Staff Report

Floodplain Development Review

FP-05-23

This staff report evaluates an application for a Floodplain Development Permit to construct a private shared access in the floodway and to construct a single dwelling unit in the Special Flood Hazard Area (SFHA) (aka 100-year floodplain). The proposed development will include grading, fill, excavation and paving within the floodway and the floodway fringe. The proposed development is upon a tract of three properties identified on Linn County Assessor's Map No. 11S-04W-12BB; Tax Lots 1100, 1101 and 1102. A location map is included as Attachment A.

SITE PLAN
 FOR
JAMES + BRENDA RUBLE
 LOCATED IN
PARCEL 2, PARTITION PLAT 2023-21 IN THE
NW 1/4 SEC. 12, T. 11 S., R. 4 W., W.M.
 IN THE
CITY OF ALBANY, LINN COUNTY, OREGON
 MARCH 14, 2023

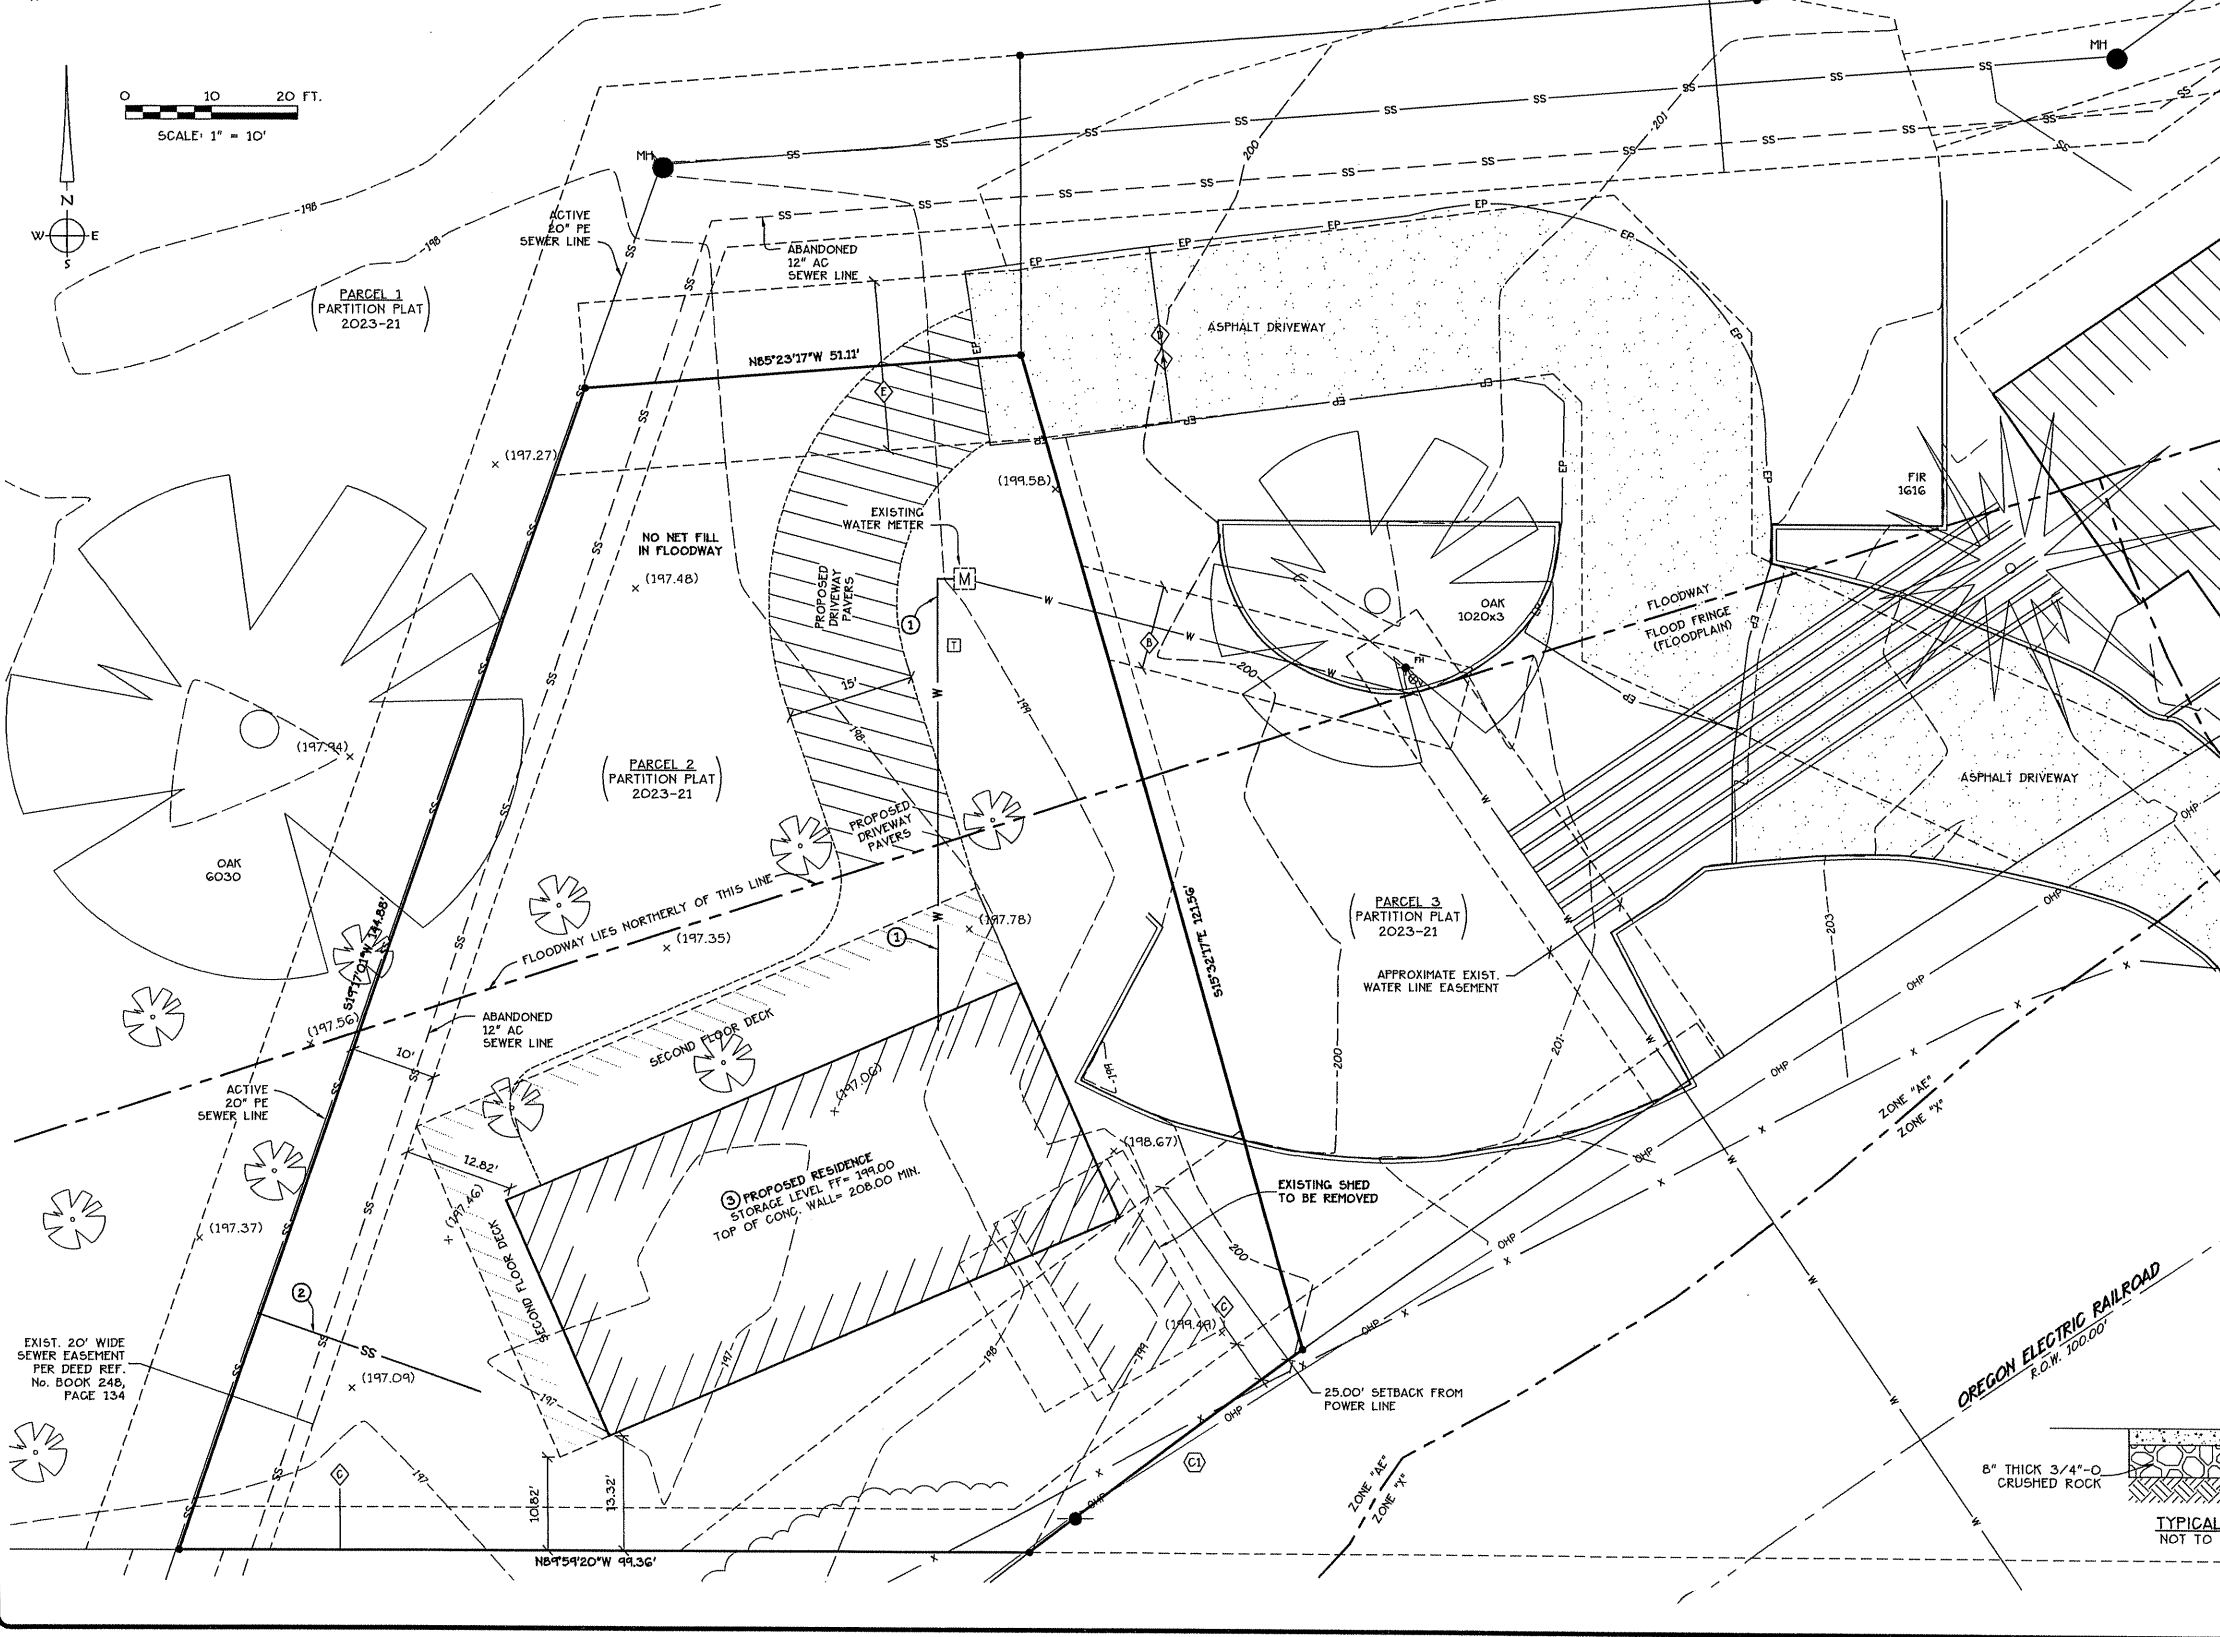
- 1.4 As shown on the site plan (Attachment B), the proposed construction of the single dwelling unit is located entirely within Zone AE of the SFHA. Therefore, the flood carrying capacity of Calapooia River is not affected by the proposed project because the fill will be placed outside the floodway.
- 1.5 At the conclusion of grading, fill, excavation and paving of the project, documentation is required to verify implementation is consistent with the preliminary plans as proposed.
- 1.6 As proposed and conditioned, the development will maintain adequate flood-carrying capacity of existing watercourses. This review criterion can be met with the following condition of approval.

- 7.1 The applicant proposes to construct a single dwelling unit within the floodway fringe. The submitted site plan (Attachment B) indicates the building is oriented so that the garage doors face toward the Calapooia River.
- 7.2 The applicant states the proposed development will be constructed under a building permit issued by the City of Albany.
- 7.3 As a condition of approval the development on the property must provide a two percent gradient toward an approved drainage facility as approved by the City Engineer and Building Official.

- Condition 1 Prior to a certificate of occupancy for future development on the property, the following documentation shall be submitted to the Community Development Department:
- a) As-built drawings with elevations provided; and
 - b) Letter from the Engineer of Record who is licensed in the state of Oregon, stating the fill was placed in accordance with the signed plans.

- Condition 2 The applicant must include a detailed storm drainage plan with building permit submittal. The drainage plan shall show how the roof drainage from the proposed structure will be discharged to a point approved by the Engineering Department.

- Condition 3 Future development of the property must provide a two percent gradient toward an approved drainage facility as approved by the City Engineer and Building Official.
